CONDITIONAL USE PLAN

PRIMROSE SCHOOLS
FRANCHISING CORP.

DERWOOD HEIGHTS
SECTION A, LOT 8

Primrose Schools: Preliminary Forest Conservation Plan No. CU2018-08

SHEET NUMBER: CUP-9

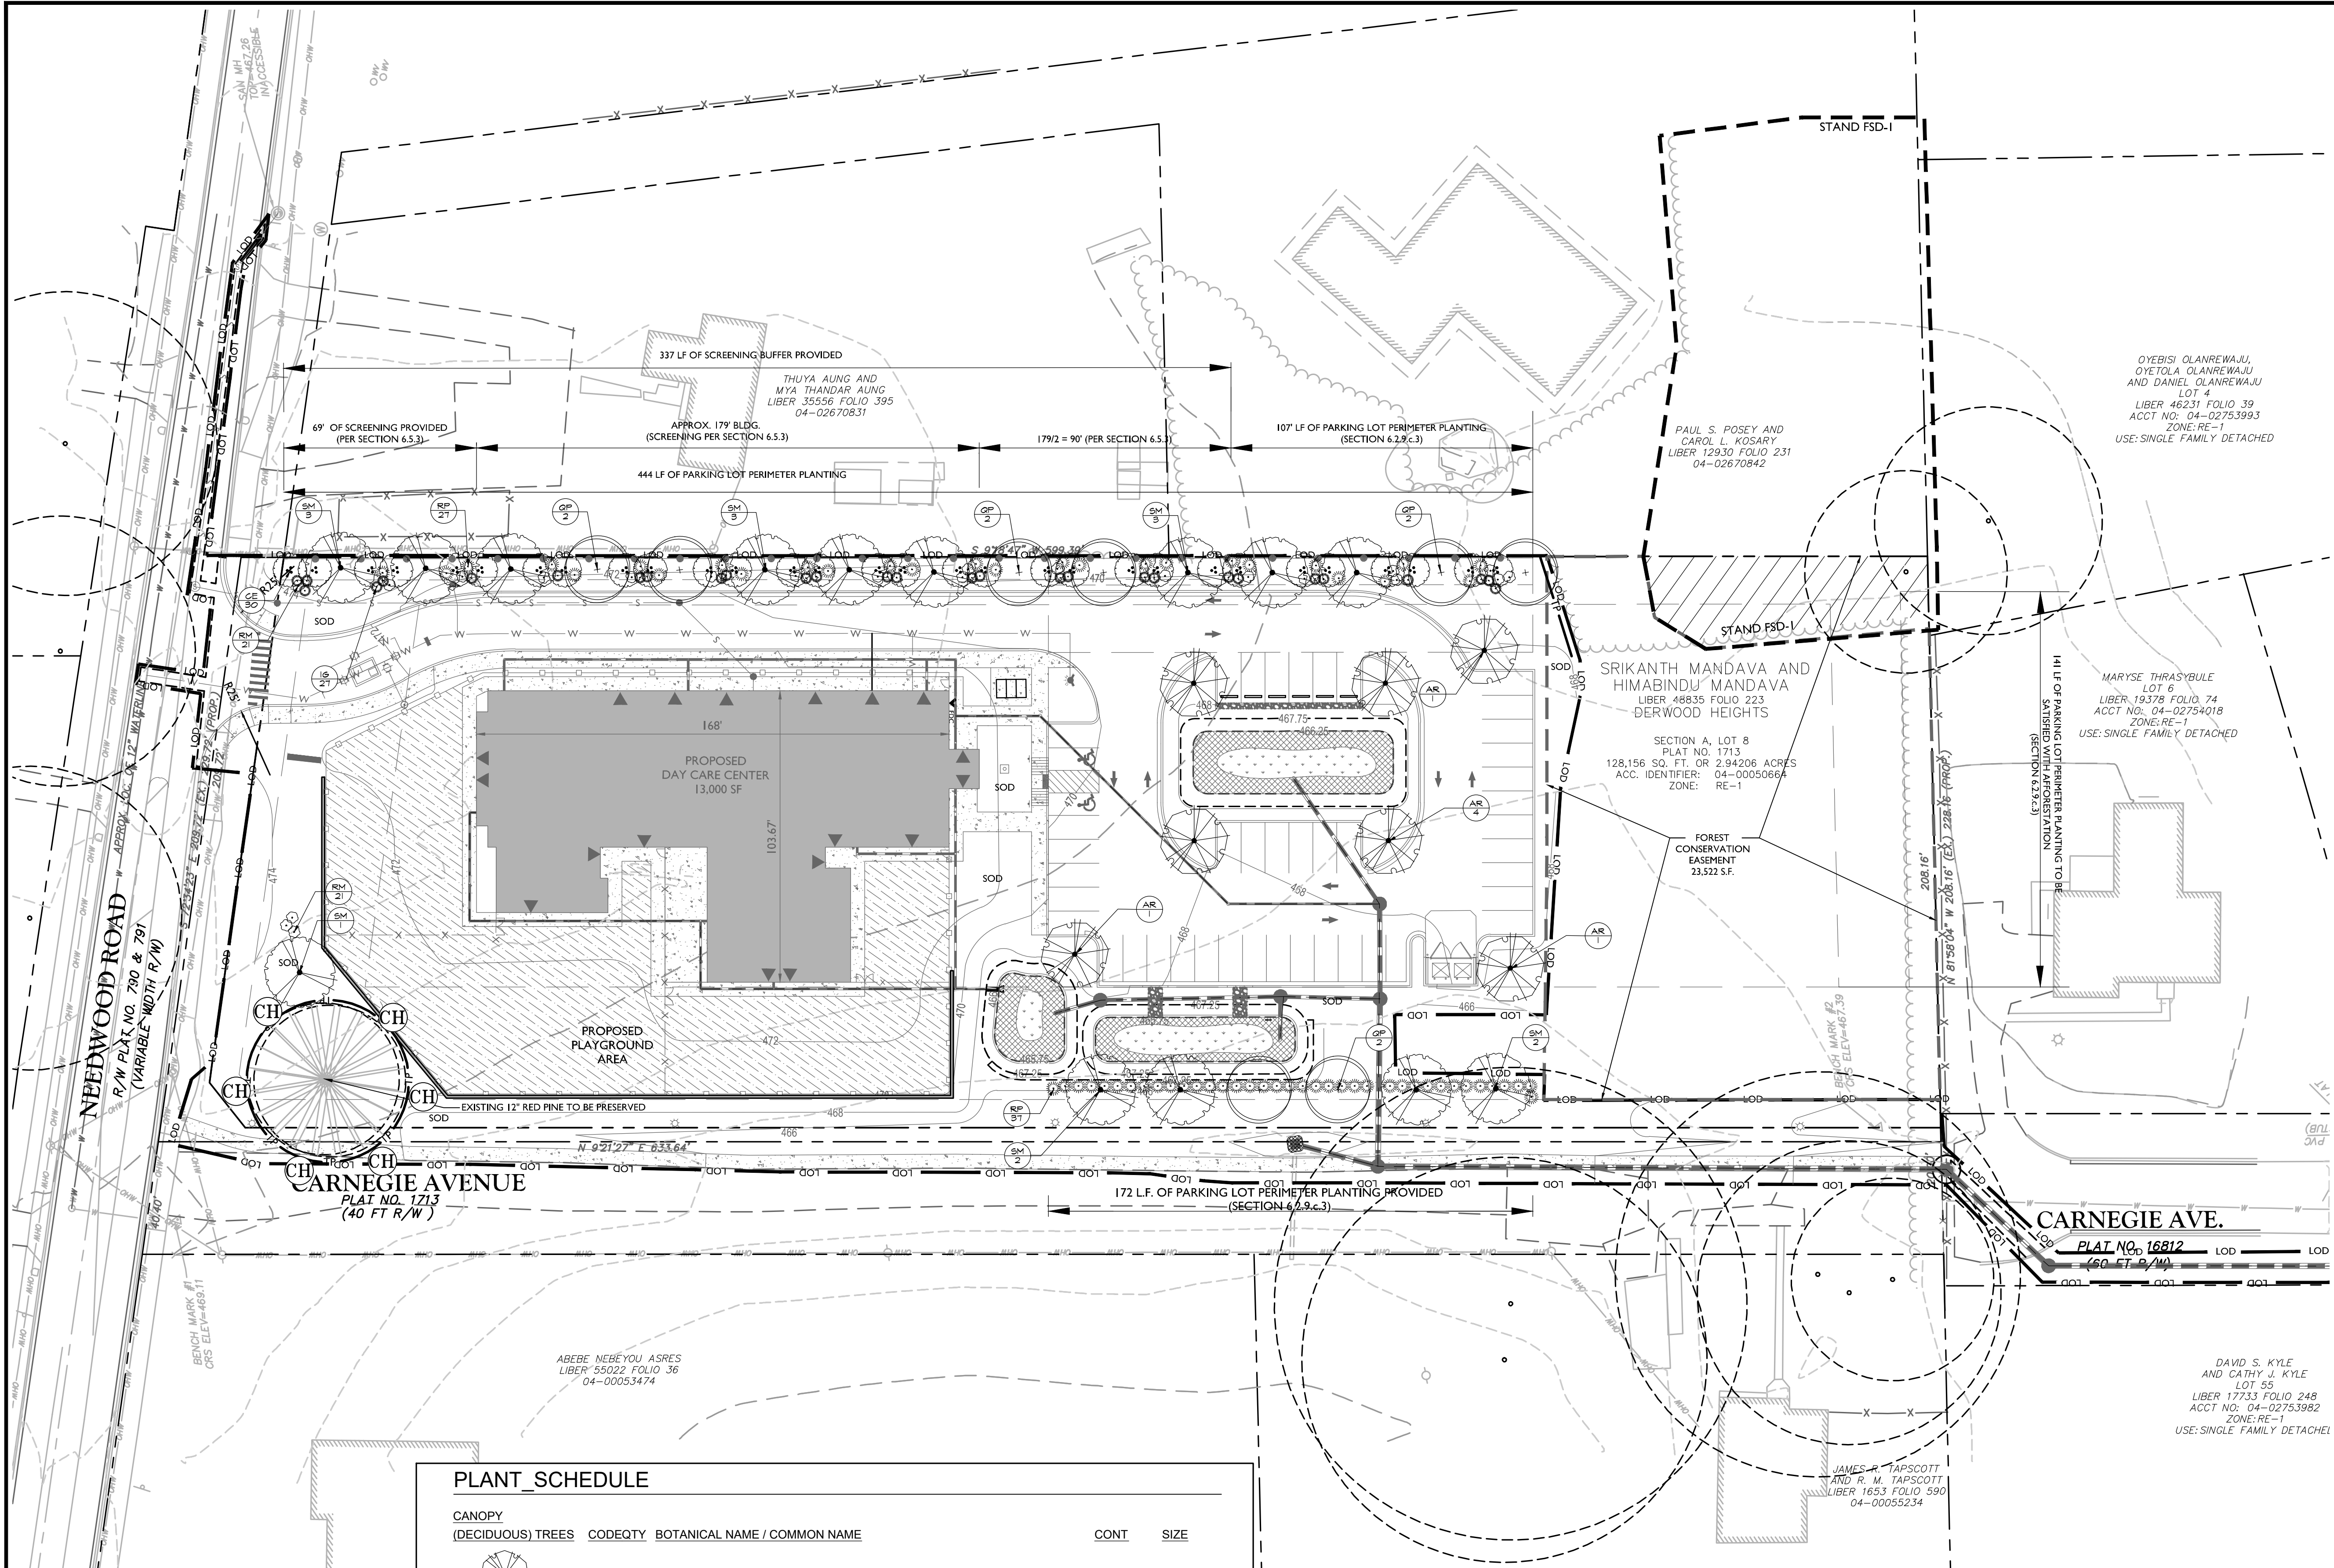
1. The Planting Schedule needs to be moved from the detail sheet to the plan sheet for clarity.

2. The tree symbology denoting both the *Acer saccharinum* and the *Quercus phellos* is the exact same symbol. This creates confusion on the plan. Please make each plant symbol different and distinct.

3. In the upper left corner of the lot there is a plant call-out specifying 2 *Quercus phellos* trees to be planted, but only one is there. The very next call-out specifies 13 *Acer saccharinum* trees, but there are 14.

4. Along the top entry drive, planting a row of 14 *Acer saccharinum* tree and one *Quercus phellos* at the end make no planting design sense. Make this a row of the same species of tree or possibly alternate between two species.

5. In the lower left corner of the lot is a tree designated as CH-1. This symbol and call-out are not on the planting schedule.

6. In the lower middle of the lot along Carnegie Ave. there is a row of trees. The symbology says these are all *Acer saccharinums*, but the call-outs specify *Acer rubrum* and *Acer saccharinum*. Once again, this planting design makes no sense with 4 *Acer saccharinums* in a row with 2 *Acer rubrums* at the end.

7. Why is there not a tree planted in the island to the upper right of the day care center adjacent to the parking lot entry drive?

8. What is the symbology along the bottom and left side of the day care center? This needs to be called out in the Legend and specified on the Planting Schedule.

9. Why are trees not planted along the frontage of Needwood Rd.?

Response: The planting schedule has been moved to the plan view sheet, as requested.

Response: The symbols were very similar, with only slight distinctions between the two. The symbol for the Willow Oak has been changed for better plan clarity.

Response: The “count” was intended to tally all the Willow Oaks along the easterly property line, with the second Willow oak being planted at the far right (southerly) end of the property line plantings. The “count” methodology has been revised to label trees in sequence. Different trees along the buffer get a new label, multiple trees (in sequence) use the same label with the total number of trees within that series of similar trees.

Response: The plantings along this row have been changed to a more balanced mix of the Willow Oak and the Silver Maple.

Response: This tree is an existing Red Pine, which is to be preserved. The plan view has been clarified, accordingly.

Response: The symbol for the Willow Oak has been changed for better plan clarity. In addition, the mix has been revised to achieve a better balance.

Response: There is no tree here due to the locations of the proposed Fire Hydrant and the Siamese Connection on the building and the workspace required in this area during an emergency.

Response: This symbol was used to depict the area that receives a proprietary cover within the playground area (“XGrass”), which is considered impervious for the purposes of SWM computations. As such, the limits that receive this treatment had to be clearly delineated. This information (brand of treatment and hatch pattern) has been included in a

Response: The trees along Needwood are not required. Additionally, there is concern regarding sight distance while leaving the site as well as visibility for the proposed monument sign at the entrance. One tree and two shrubs have been added outside the line of sight, as established by the existing evergreen at the northwest corner which is to be preserved.

Figure 3. PFCEP showing impacted variance trees

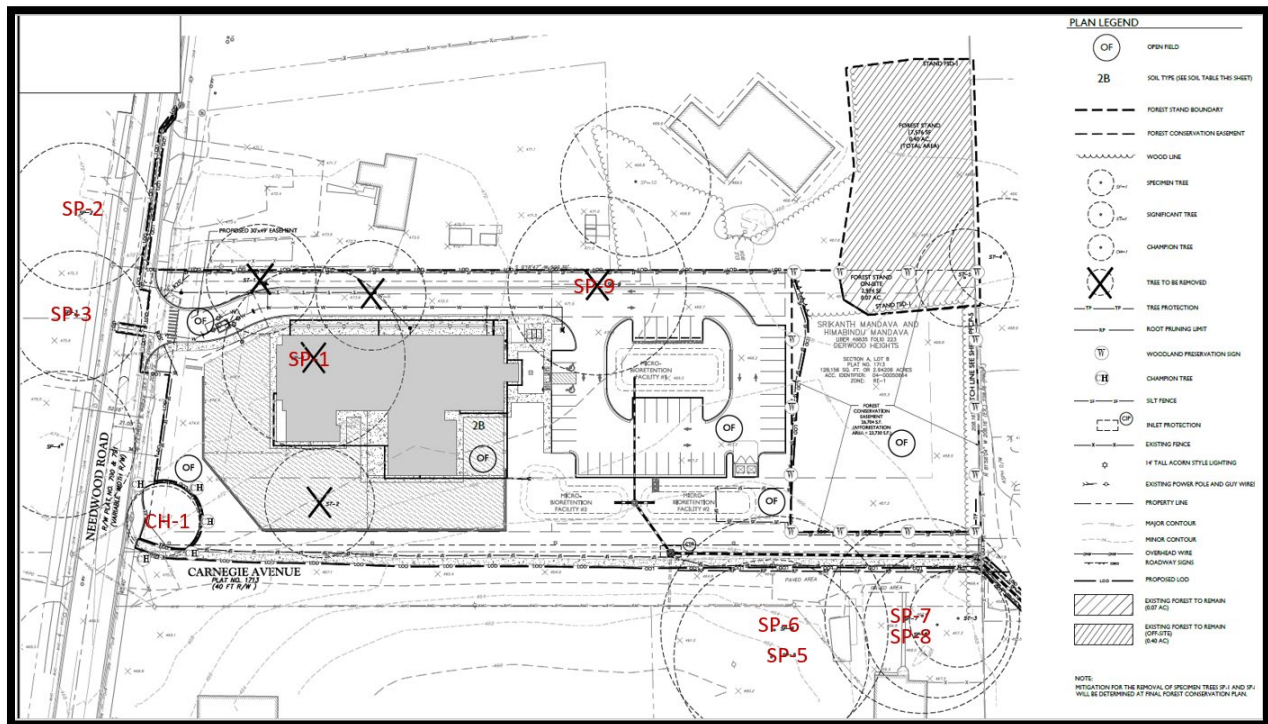
Trees SP-1 is internal to the site and located close to the existing site such that protection of this tree would be difficult under any redevelopment process. Denying the variance request would create an unwarranted hardship to develop this site and not impact less than 30 percent of the CRZ's of Tree SP-1.

Tree SP-9 is located along the eastern site perimeter. Because of all the trips associated with this use, the location of the drive was moved from Carnegie Avenue to its present location. Development according to RE-1 standards with far fewer trips would allow much more flexibility with the driveway location and the ability to preserve SP-9. The proposed use could give SP-9 the potential for survival if the driveway and parking lot configuration could be altered and special measures used to protect the

Therefore, Staff concurs that the Applicant has a sufficient unwarranted hardship to justify a variance request for all specimen trees with the exception of Tree SP-9.

Variance Recommendation - Staff recommends approval of the variance request with the exception of tree SP-9.
